PHILIPS

SERVICE NOTES

BX1000

N.V. PHILIPS' GLOEILAMPENFABRIEKEN EINDHOVEN	Betreft: BX 100 U	WD 592
SERVICE		1.3.51

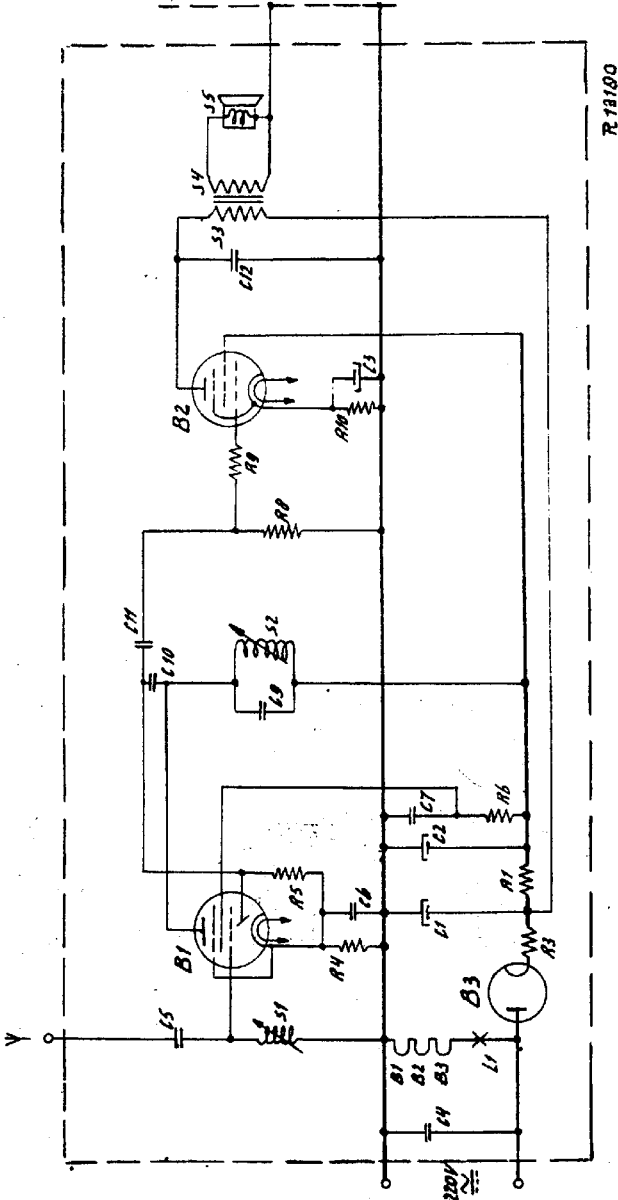
In the documentation of the BX 100 U an error has been detected. The tube B1 is not the UCH42, but the UAF42. Further in this documentation two resistors RA and RB are mentioned, by means of which the set can be made suitable for mains tensions 110 V and 127 V. As the resistors RA and RB have an unusual value which cannot readily be supplied, one must use a N.T.C. resistor (code number 49 379 62) for RA and RB an enamelled resistor (80 ohm, 6 W) (code number 48 494 10/180E).
